**2318ADDSN - Addendum No. 1  
To Plans, Contract Documents and Specifications**

**Addison Municipal Airport (ADS)  
Taxiway B Extension – Phase I  
TxDOT CSJ No. 2318ADDSN**

### PRECAST SAFETY END TREATMENT

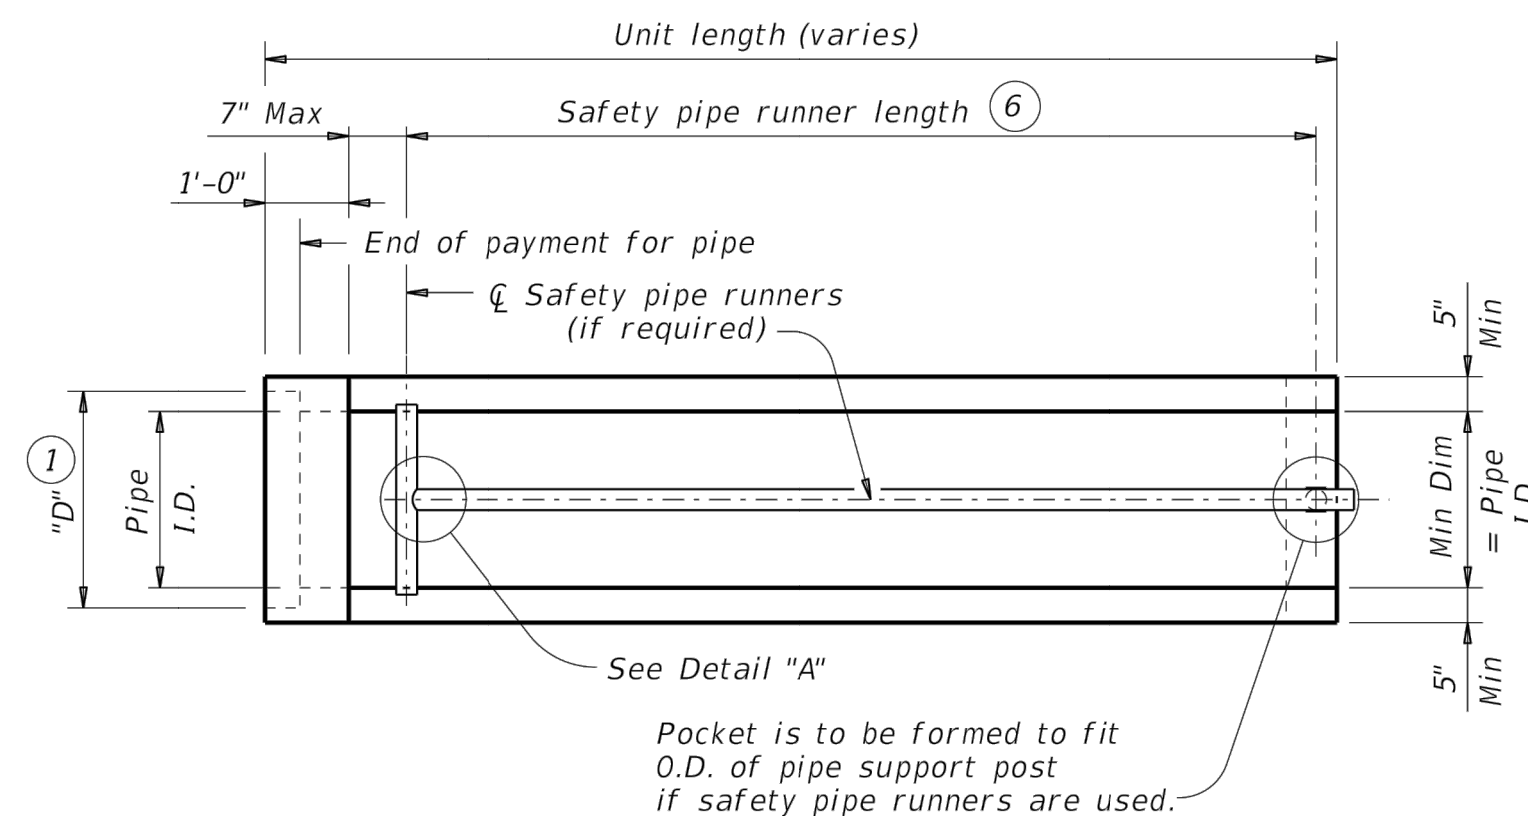
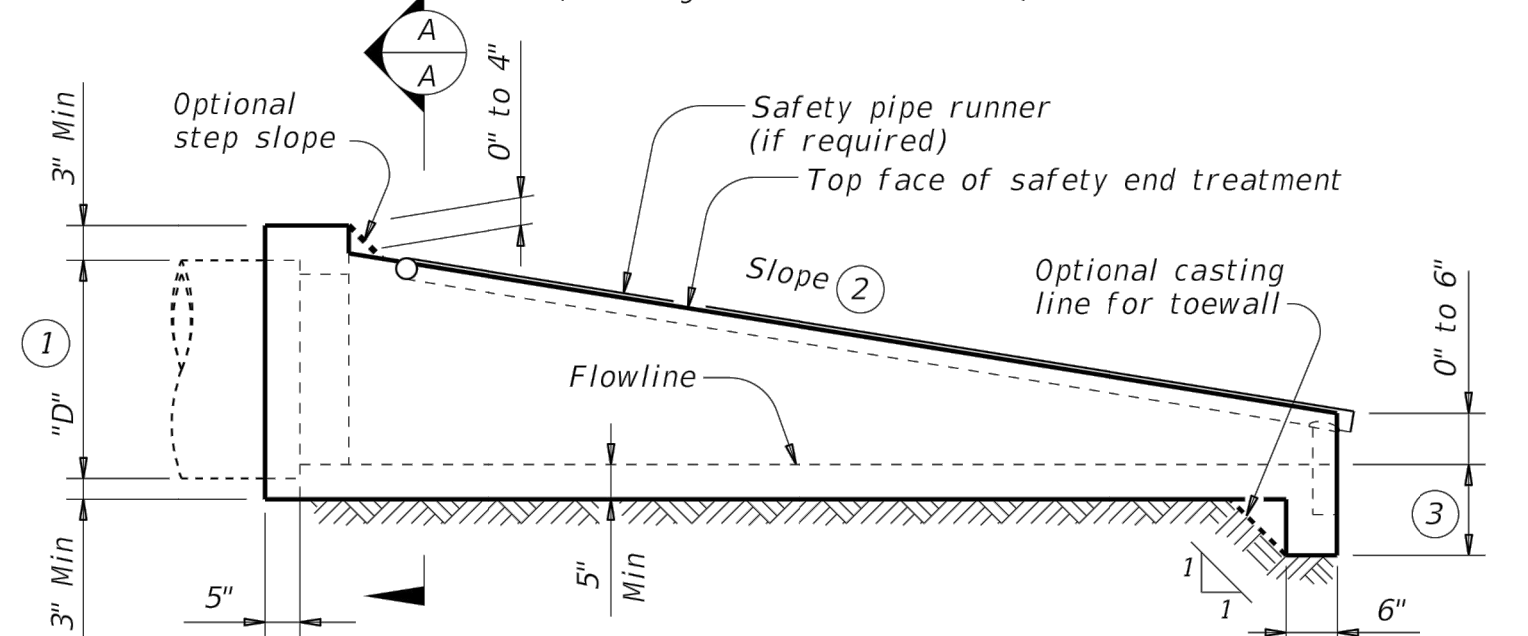
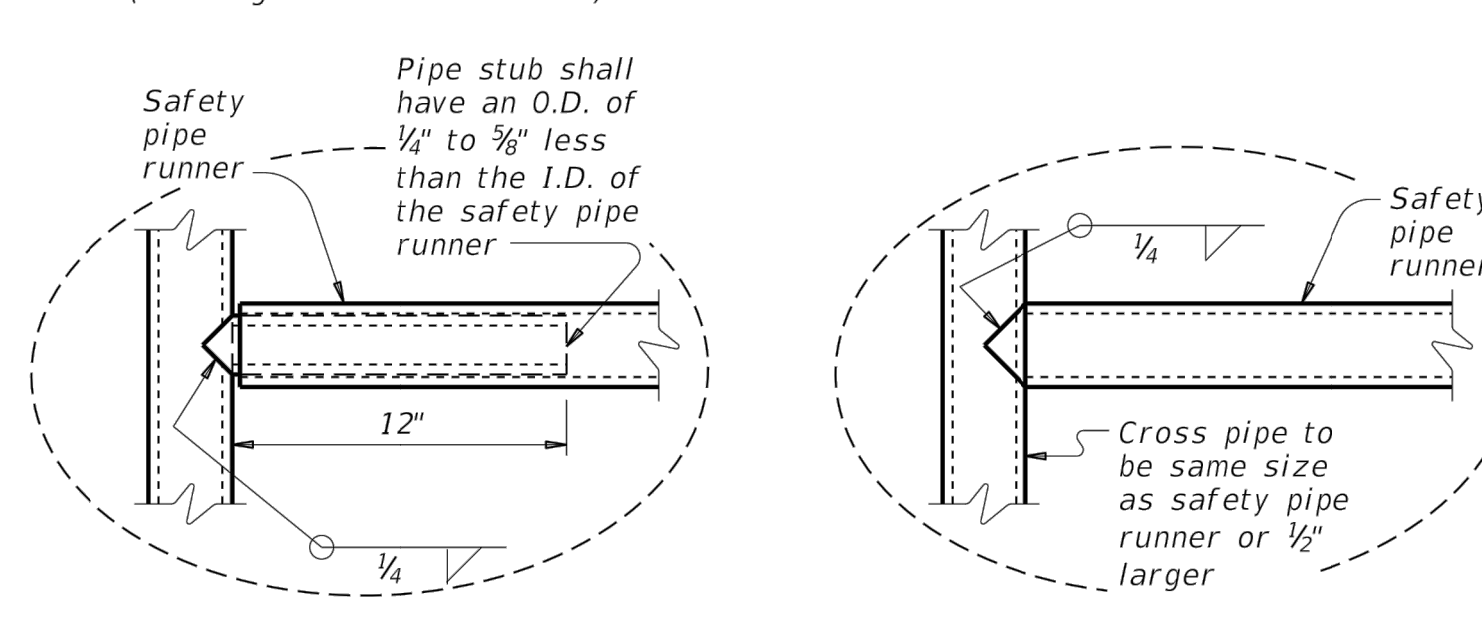
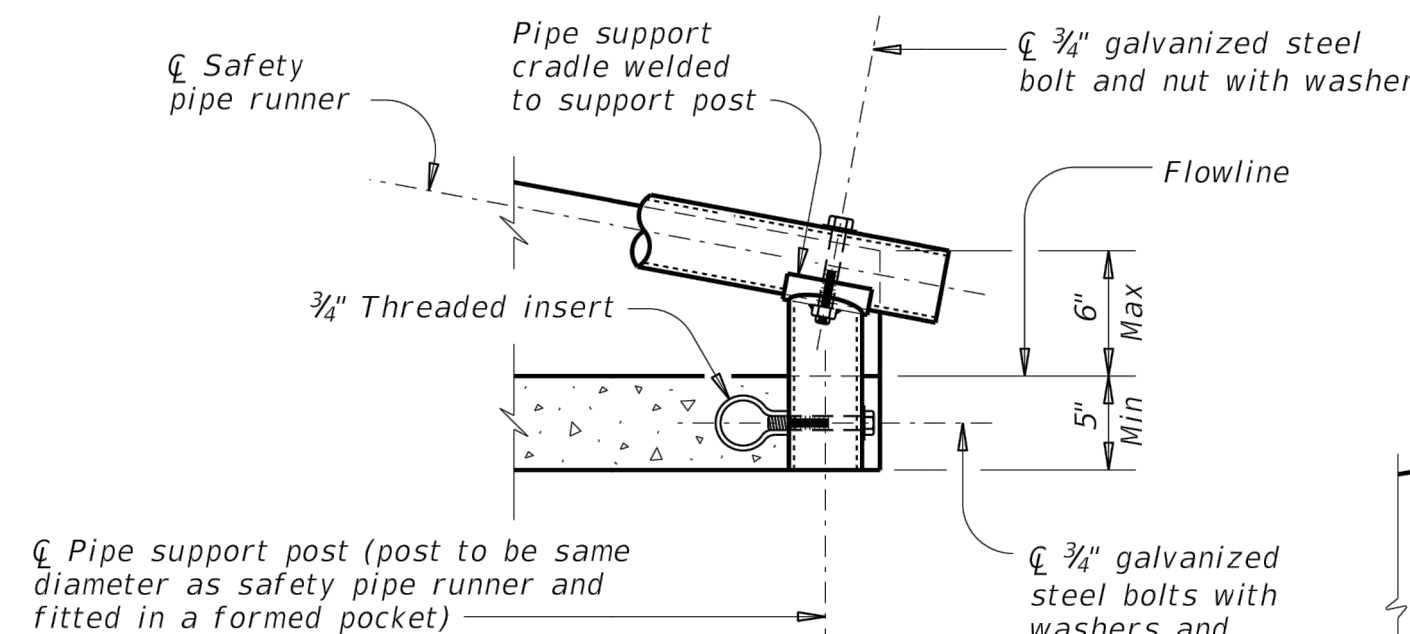
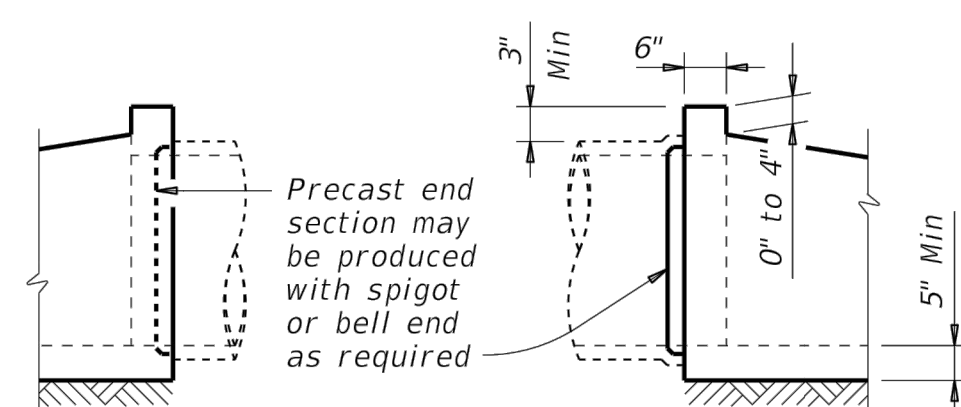
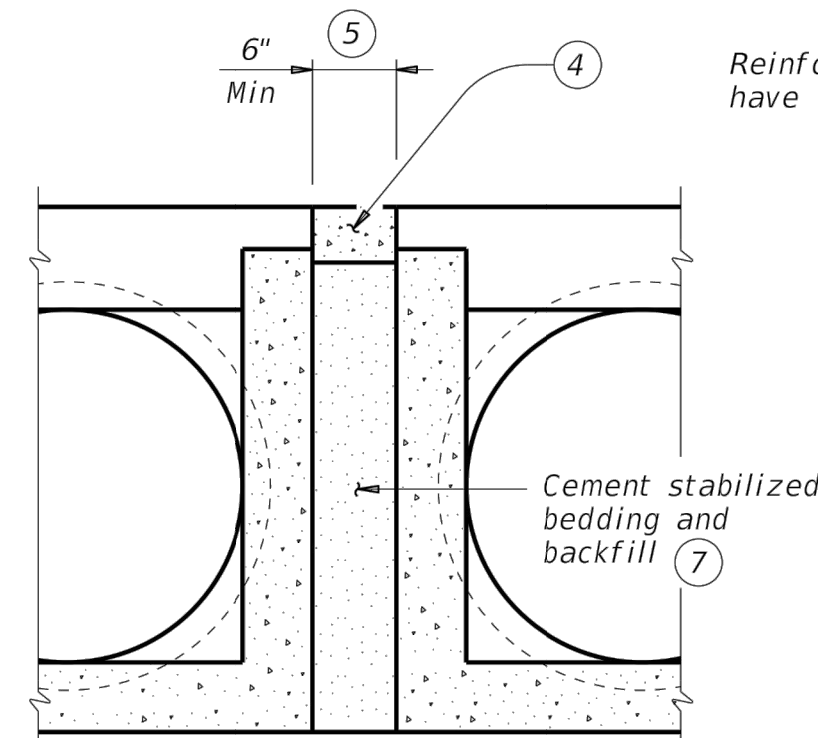
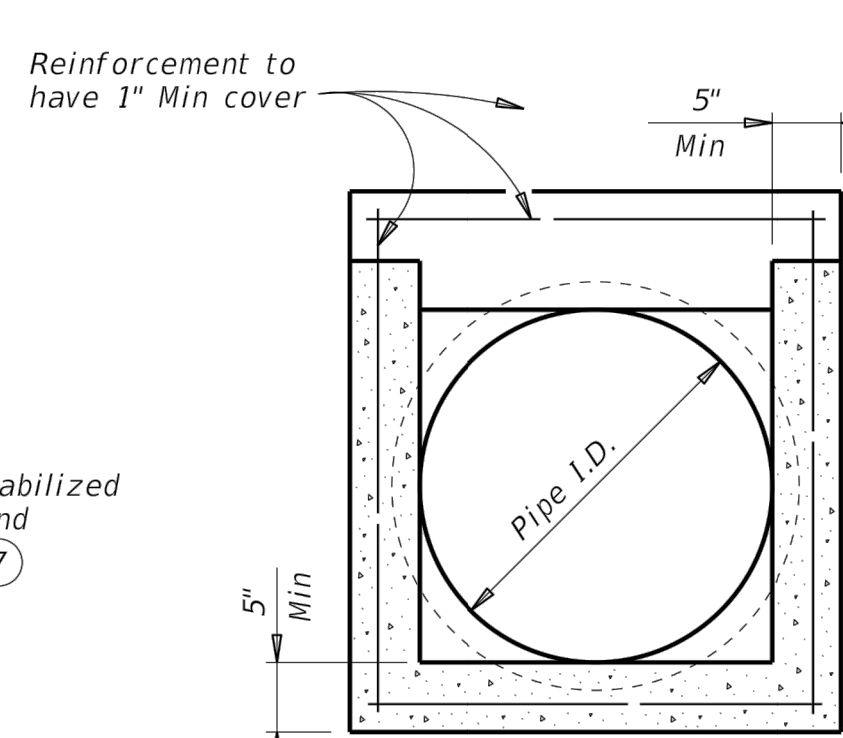
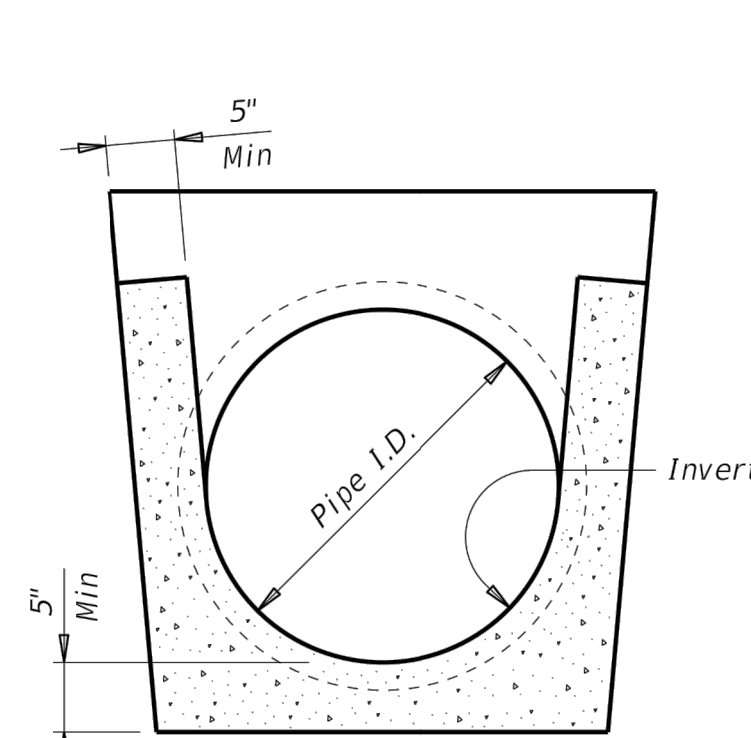
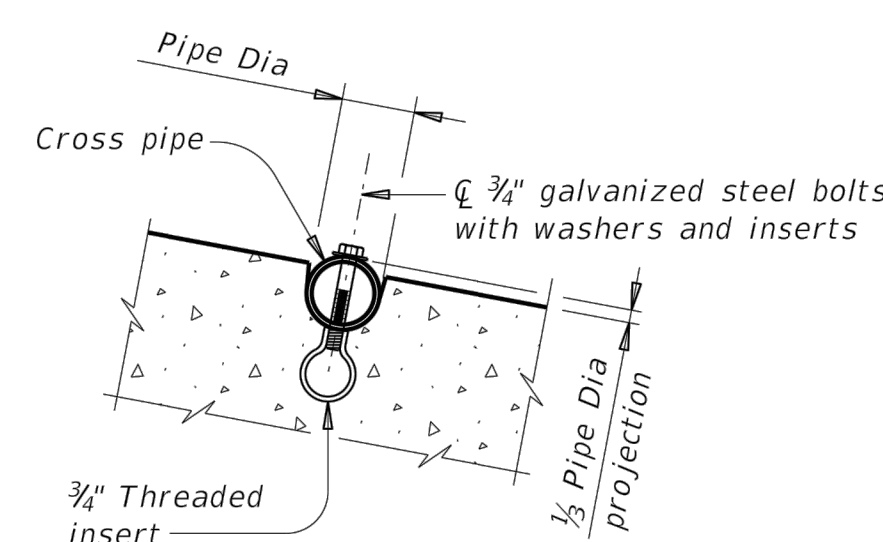
Sheet CC-504: The scale of the TxDOT detail was adjusted to properly fit the page.

- e) Sheets 38 – 40 did not plot correctly, can you reissue these?
  - Yes, these sheets will be corrected and reissued in Addendum No. 1.
- f) The hatch pattern for the Concrete Encased Pipe detail on plan sheet 162 is for CTB. The note says 6" Lime treated subgrade. Can you confirm which is required?
